HI-STAR 100 CERTIFICATE OF COMPLIANCE 71-9261

CERTIFICATE AMENDMENT REQUEST 9261-1

November 24, 1999

Subject: NRC 10 CFR 71 Certificate of Compliance No. 9261, Docket No. 71-9261
License Amendment Request 9261-1

FIGURE 5.3.9; HI-STAR 100 OVERPACK WITH MPC-24 CROSS SECTIONAL VIEW SHOWING THE THICKNESS OF THE MPC ~~SHIELD-SHELL~~ AND OVERPACK AS MODELED IN MCNP

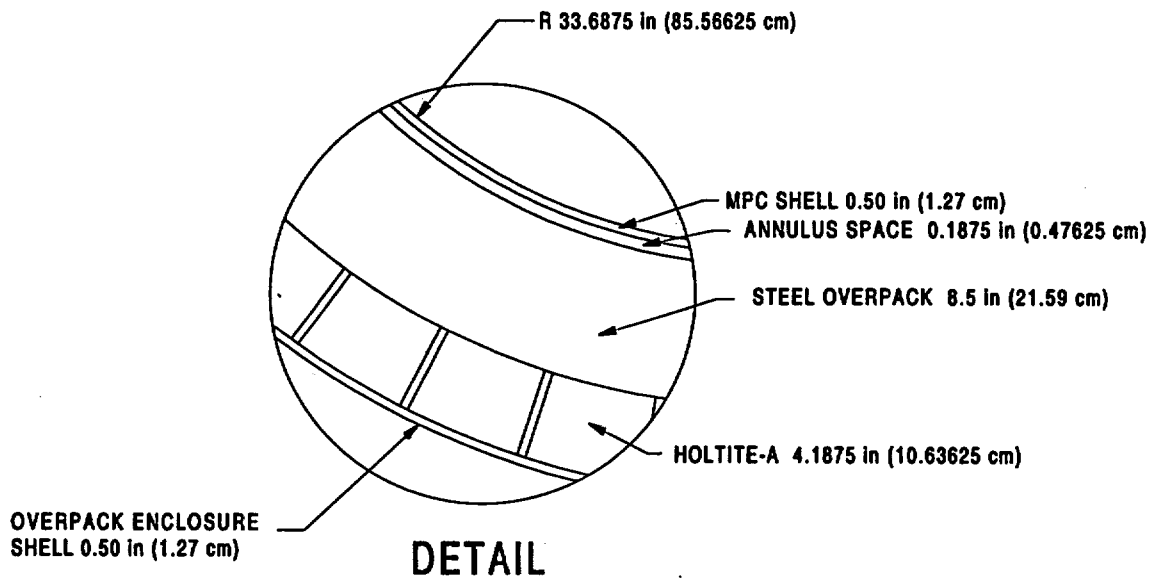
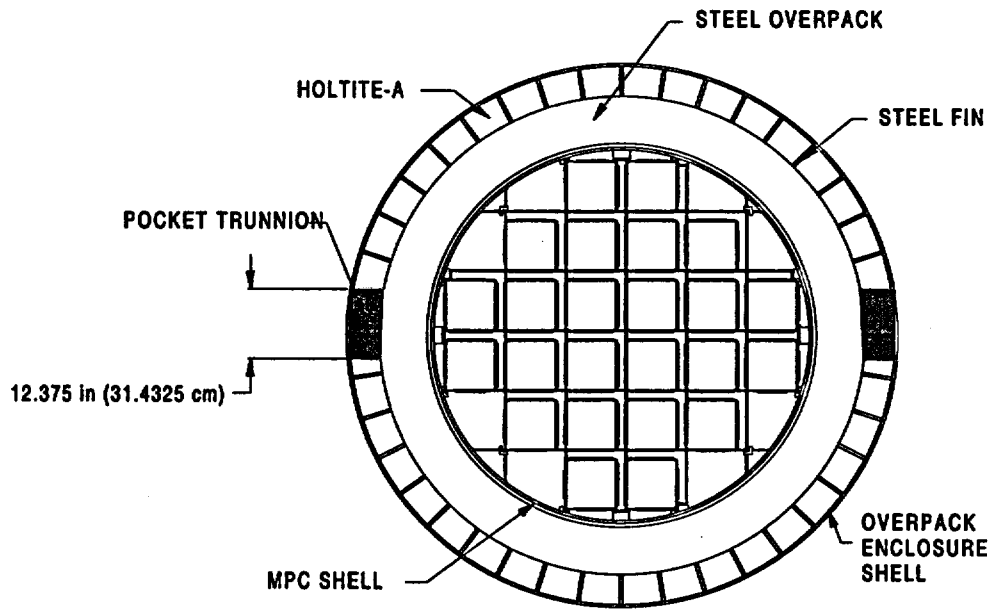
- k. Figure 5.3.9 is revised to correct a typographical error.
- l. New Subsection 5.4.5 is added to discuss the source terms for the Dresden Unit 1 antimony-beryllium neutron sources which are being added to the allowable contents for the HI-STAR 100 package.
